**Five-Year Review Report for
Installation Restoration (IR) Site 9 - Operable Unit 1
Marine Corps Base Camp Pendleton
Camp Pendleton, California**

**Five-Year
Review Report**

Appendix A Responses to Regulatory Review Comments Matrix

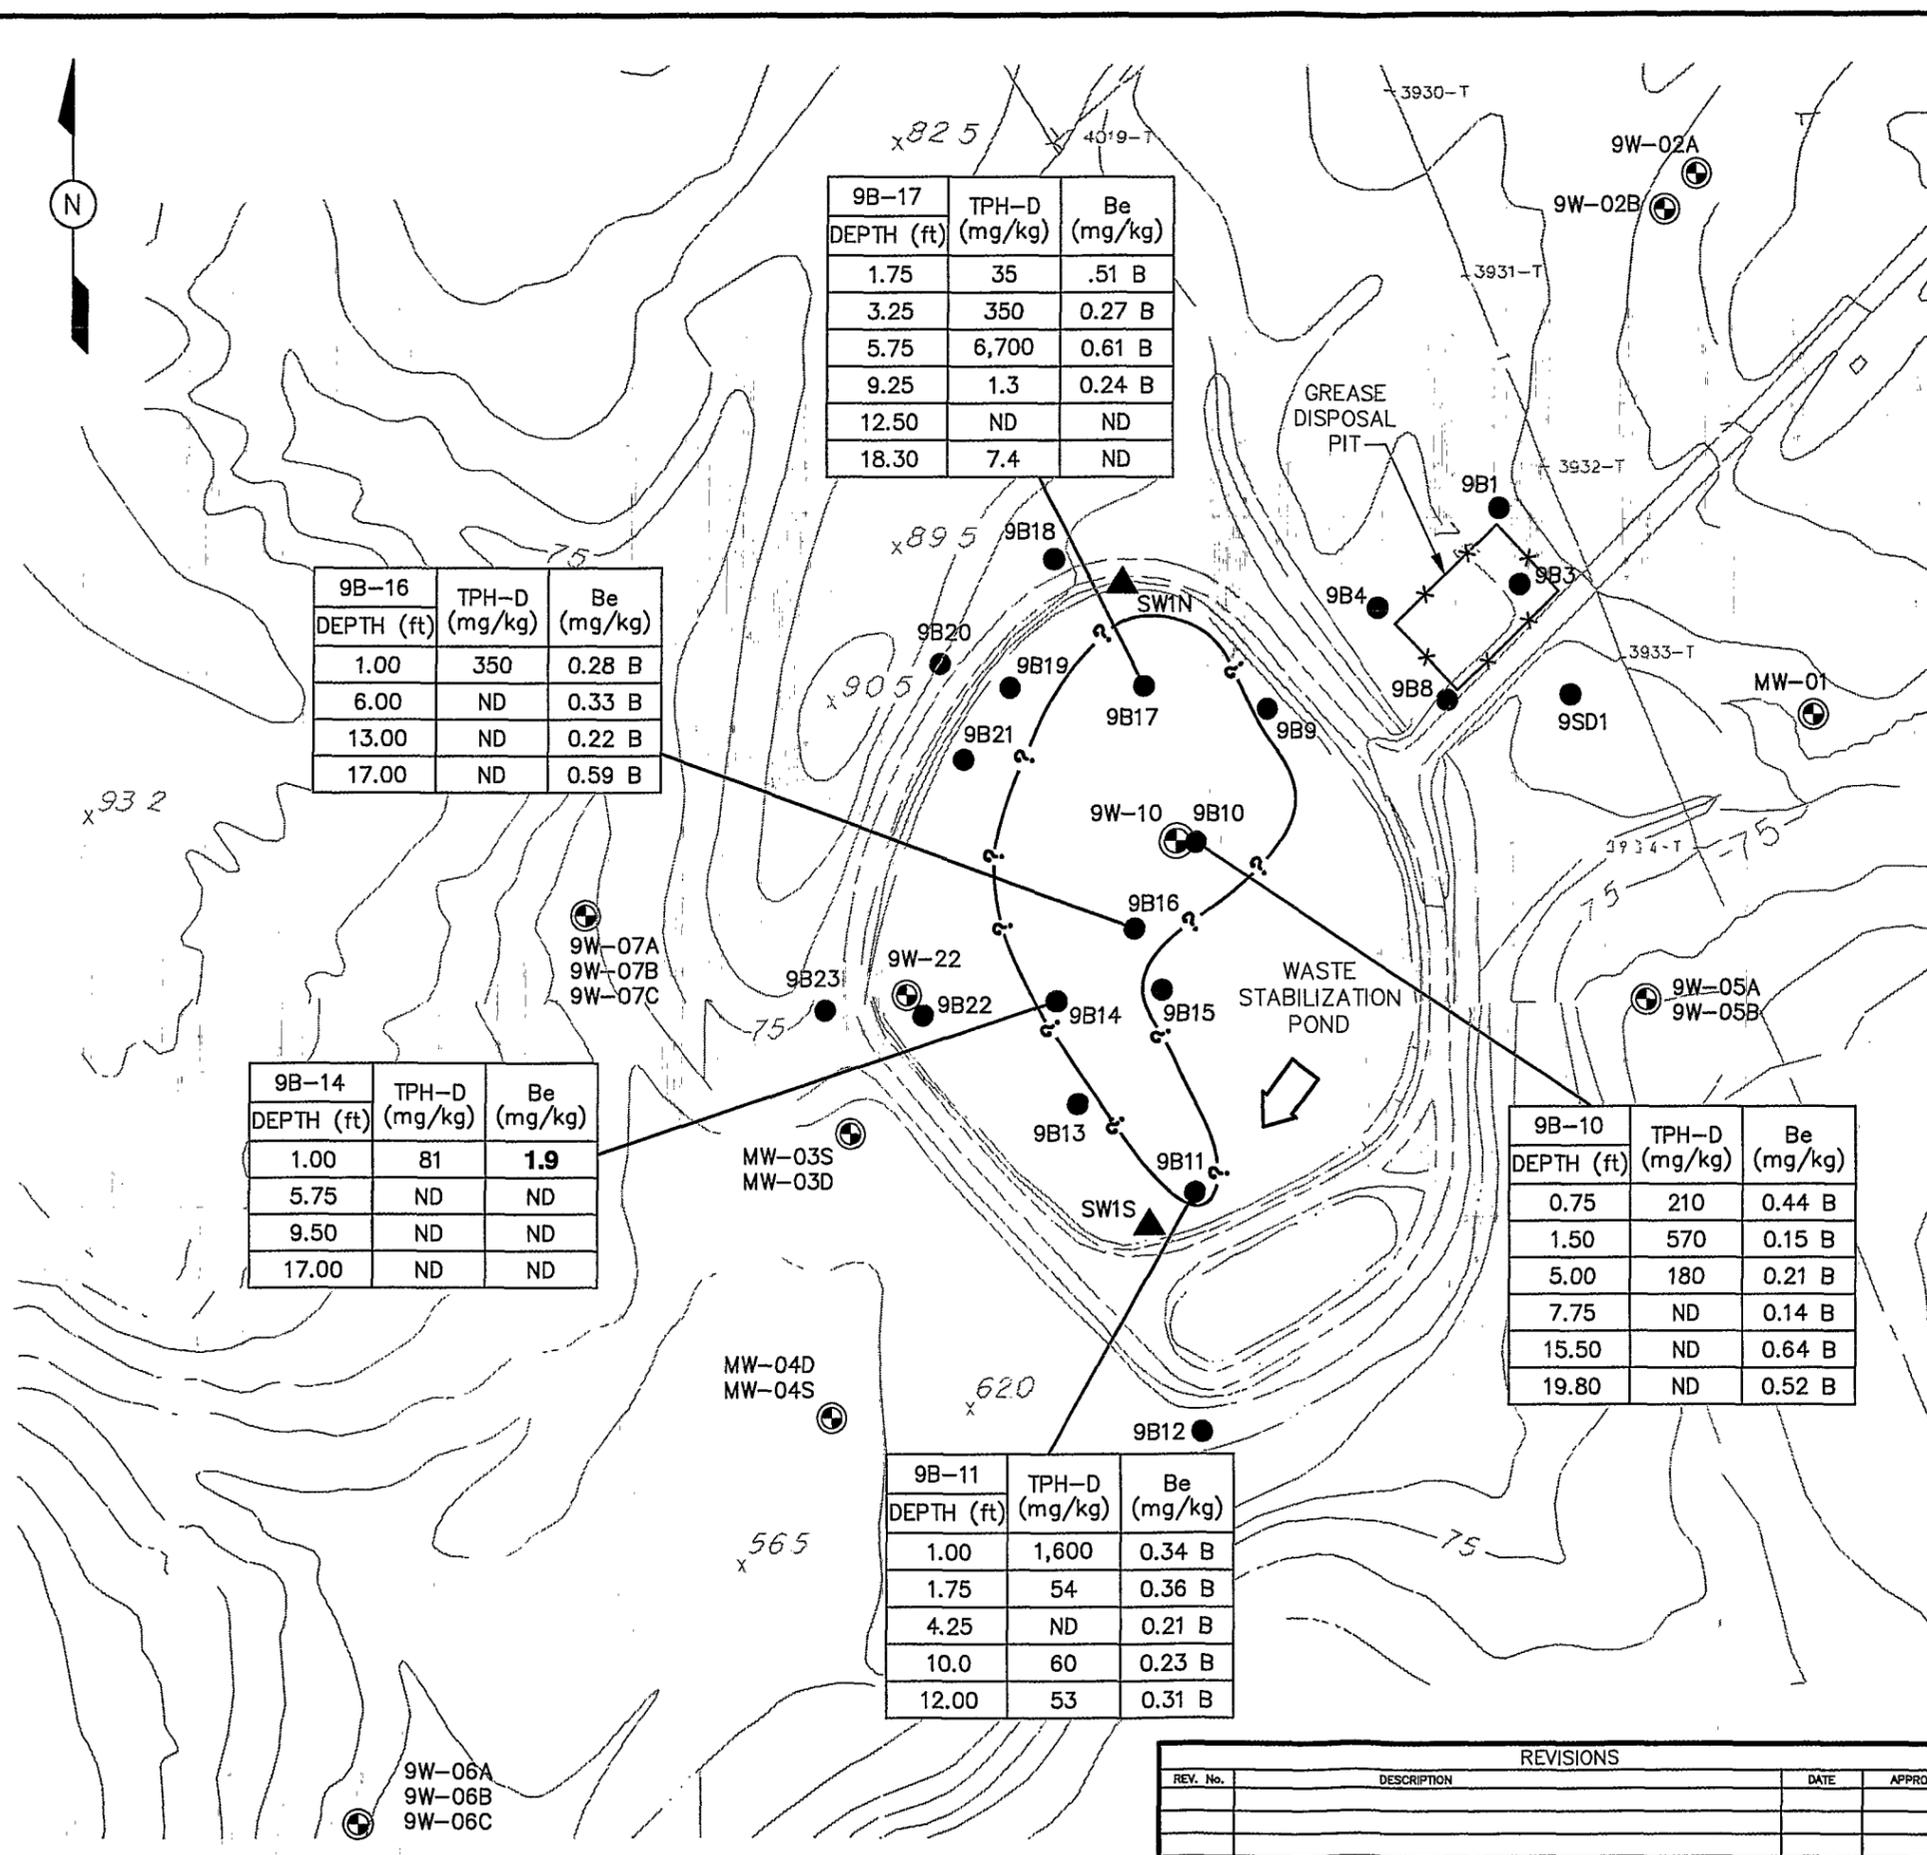
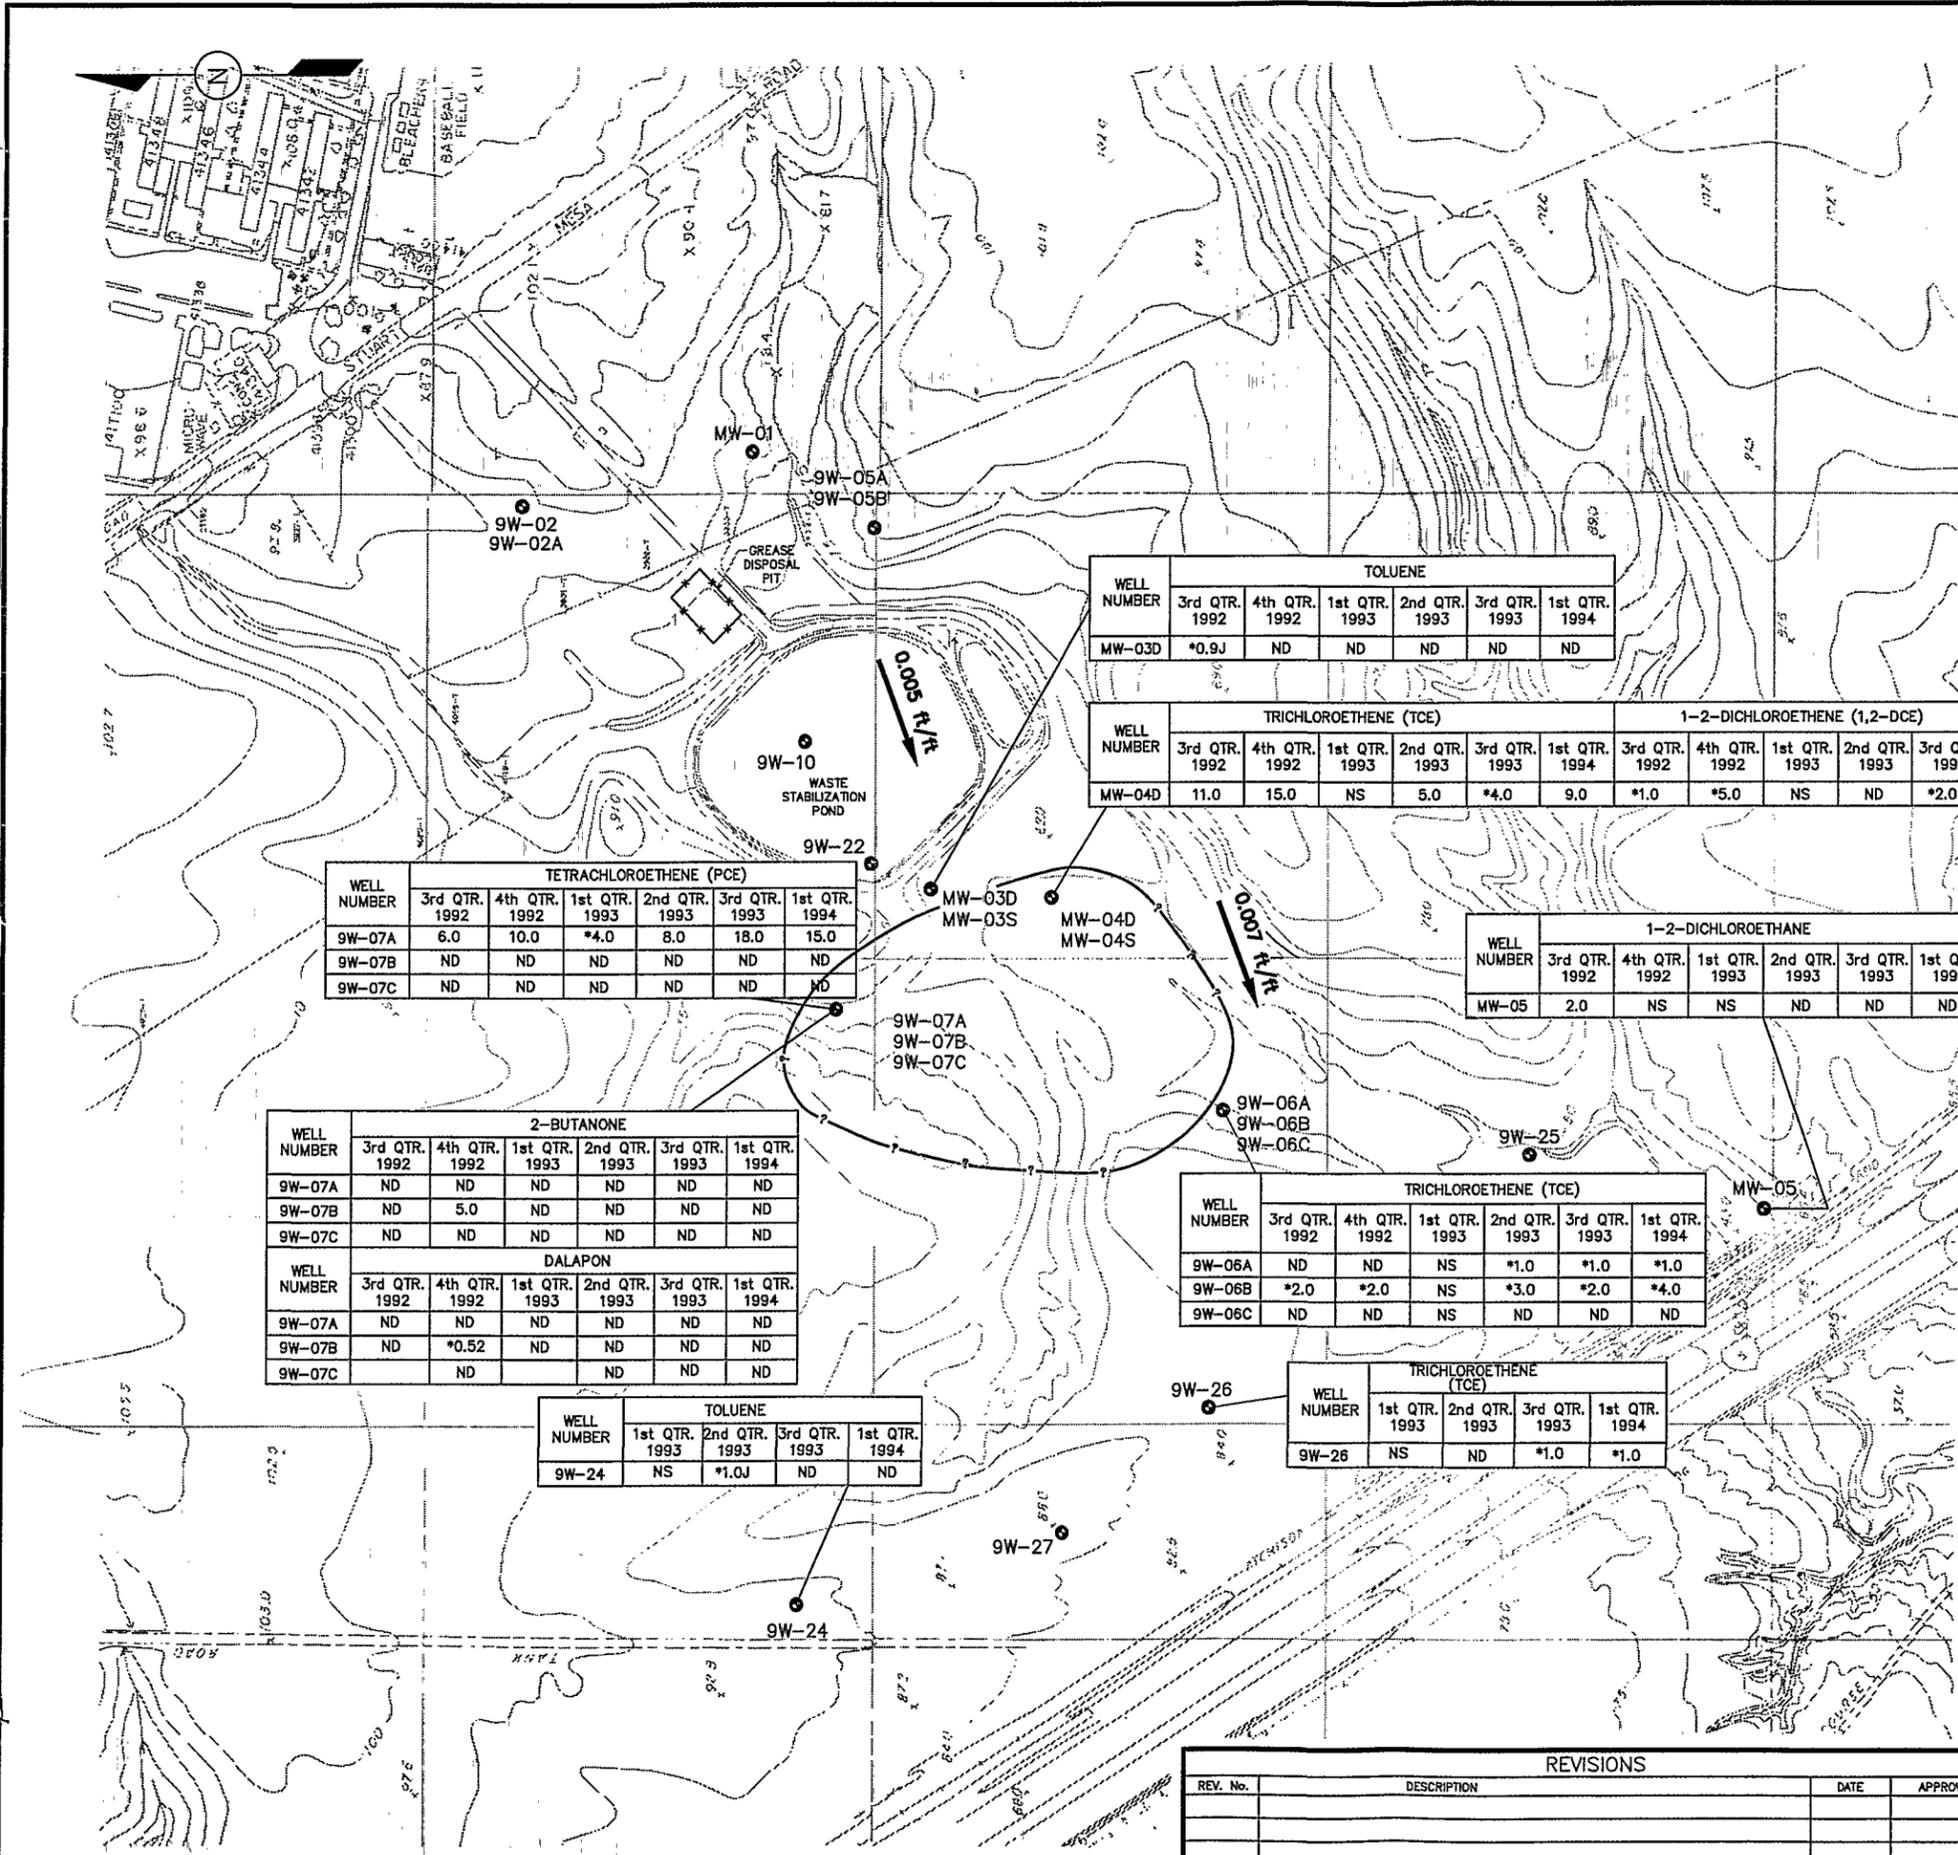
8.	Section 3.4.1, Soil and Vadose Zone, page 3-2.	It appears from Figure 3-3 that although soil samples from 19 borings were collected during the RI/FS, a good portion of the former effluent lagoon (the southeast quadrant) was not sampled. This is inappropriate, since a significant portion of the lagoon (approximately 25%) was not adequately characterized and a potential source could have been missed. If a source was missed, that could explain the increase in PCE concentrations in groundwater. Natural attenuation should be selected only after sources of contamination have been removed or remediated.	As discussed in our response to your general comments, we believe the RI adequately addressed soil contamination at the site (the previous wastewater processing pond and grease disposal pit). We may, however, perform additional soil investigation if future groundwater monitoring data indicate the existence of a previously unidentified source of PCE or TCE. We will share our plan with you if the additional groundwater data support the need for future soil assessment.

9.	Ibid, 1 st bullet.	The TPH concentration in soil boring 9B-17 at 6 feet below ground surface is reported as 67,000 mg/kg and 6,700 mg/kg in Figure 3-3. Please correct this discrepancy.	The TPH concentration should be 6,700 mg/kg. The text will be revised accordingly.

3.	Section 3.4.2, Groundwater, Page 3-3, Reference to Figure 3-3.	Total Petroleum Hydrocarbon as diesel (TPH-D) is apparently limited to shallow soils, and these data are only for the source area. No other data, tables or figures are presented to characterize other chemicals present in this source area (particularly analytes of the VOC, metals, and SVOC suites).	The focus of this review is to evaluate whether the selected remedy is protective of human health and the environment. The exposure risk associated with the soil contamination at Site 9 was deemed acceptable and requires no further action. Detailed information on soil contamination at Site 9 was presented in previous RI reports and will not be repeated in this report.
